Comprehensive Everglades Restoration Plan (CERP)

Acme Basin B Discharge

Comprehensive Everglades Restoration Plan (CERP):
Acme Basin B Discharge Project
Public Workshop Summary

November 19, 2003

Keith Jones presented an overview of the ABBDP study area. A map is shown below:

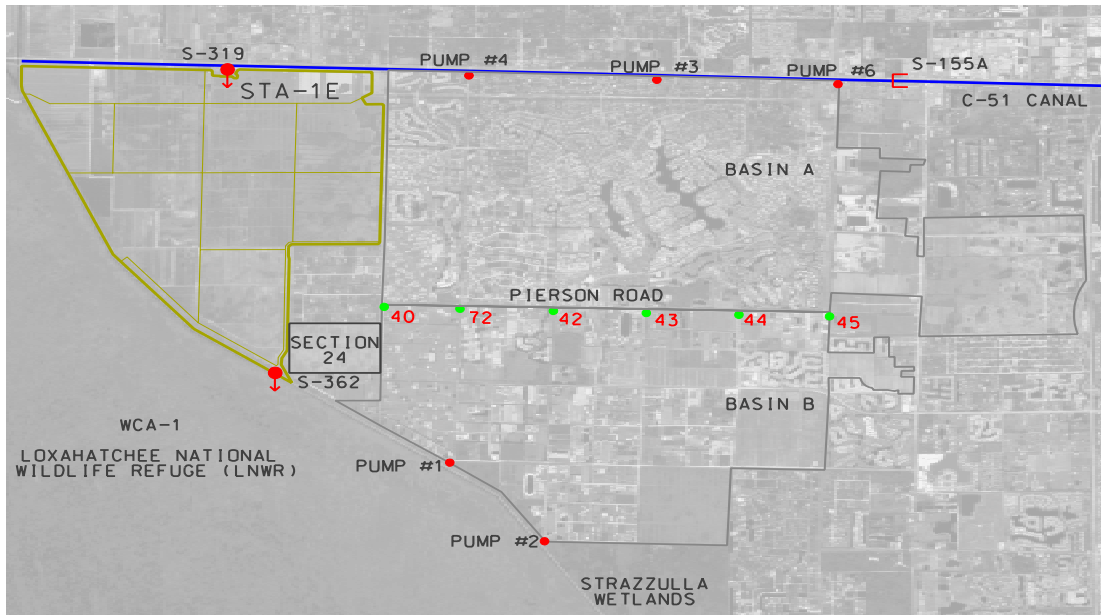
1. Question: What is the future plan for pumps #1 and #2?

2. Question: Would the maintenance of canals at 12 feet cause seepage from the Refuge (elevation 15 feet)?

3. Question: Do you have phosphorous goals for Section 24?

- 5. Question: Would it be faster to pump Basin B flows from C-1 into C-51 and then into STA 1-E?**

- 8. Question: Are canal/culvert improvements required with the optimized plan (Alternative 3)?**

- 9. Question: Will all flows from Basin B and A be routed through Section 24 for pre-treatment?**

- 10. Question: If you put 4 feet of water in Section 24 (operational elevation 12 feet), would it have an affect on the 230 acres of residential land in the southern portion of Section 24?**

11. Question: Would there be too much muck in the Section 24 soils to support the wetland design?

13. Question: Why do the ABBDP alternatives not consider routing Basin B flows north in Basin A on the east of the C-1 canal in the vicinity of the Wellington Green Mall?

Response by the ABBDP Project Team: For the purpose of the ABBDP, it is assumed pumps 1 and 2 would not be operational for discharge of Basin B runoff to the Refuge. However, pump #2 would remain available to supplement the Village of Wellington water supply and maintenance of canal elevations during dry periods under an existing consumptive use permit.

Response by the ABBDP Project Team: Seepage was addressed in the Basin Specific Feasibility Study and it was determined implementation of the ABBDP would not have a seepage impact on the Refuge.

Response by the ABBDP Project Team: No goal has been identified, however, there would be water quality benefits derived by temporarily storing water in Section 24.

Response by the ABBDP Project Team: Yes. This is the flow route for Alternative 1. However, no water is moved through Basin A as the Pierson Road culverts are closed. All water is moved through C-1. The evaluation of Alternative 1 would determine whether it would be better to pump all water directly into the STA-1E distribution cell or indirectly via the C-51 canal and pump 319. A survey is required to determine the conveyance improvements needed for the C-1 canal to discharge 491 cfs into the C-51.

Response by the ABBDP Project Team: The hydraulic model would determine if canal conveyance improvements are required.

Response by the ABBDP Project Team: According to the Basin Specific Feasibility Study even without Section 24, water quality targets can be met. Large rainfall runoff events can be pumped into Section 24 for pre-treatment to further reduce loads.

Response by the ABBDP Project Team: ABBDP cannot impact the level of service in any adjacent areas. Section 24 would be excavated to create a berm that would protect the adjacent lands.

Response by the ABBDP Project Team: A geotechnical investigation will be performed to support development of the detailed design.

Response by the ABBDP Project Team: This potentially could be looked at in the vicinity of pump station #6.
